T10/07-321r3

**To** INCITS T10 Committee  
**From** Michael Banther, HP  
**Subject** ADT-2 Negotiation State Machine  
**Date** 17 September 2007

**Figure 5 – Link Negotiation State Diagram**

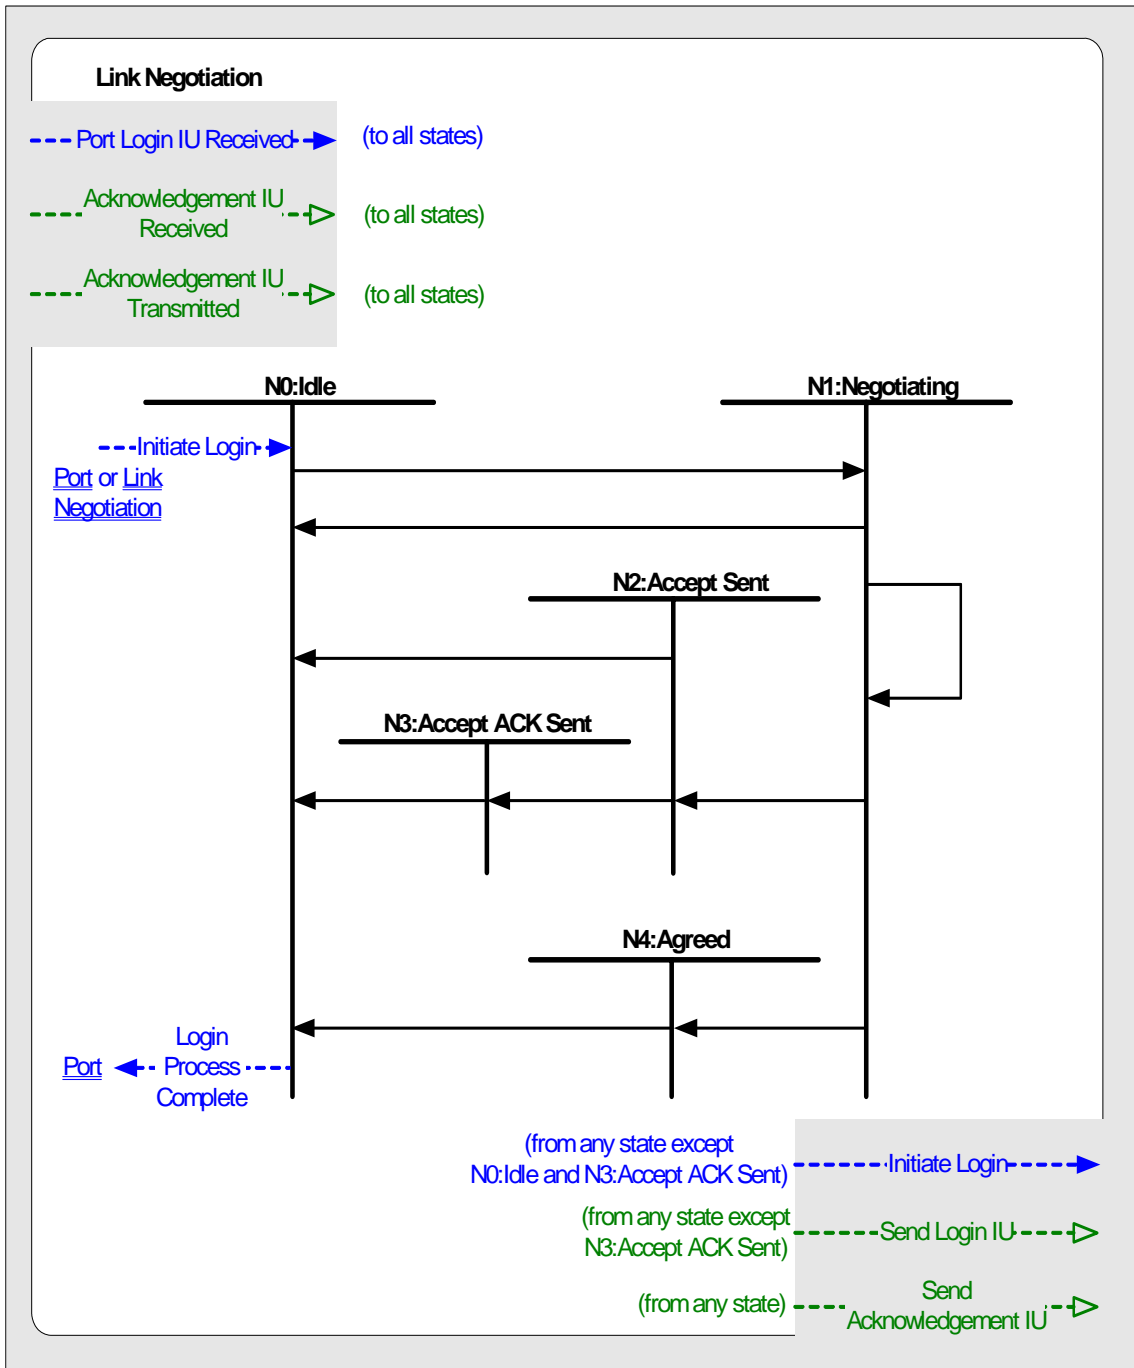
Revision 2 – Added figure 5.

Figure 5 shows the link negotiation state machine. The following subclauses describe the transitions and the actions taken in each state.
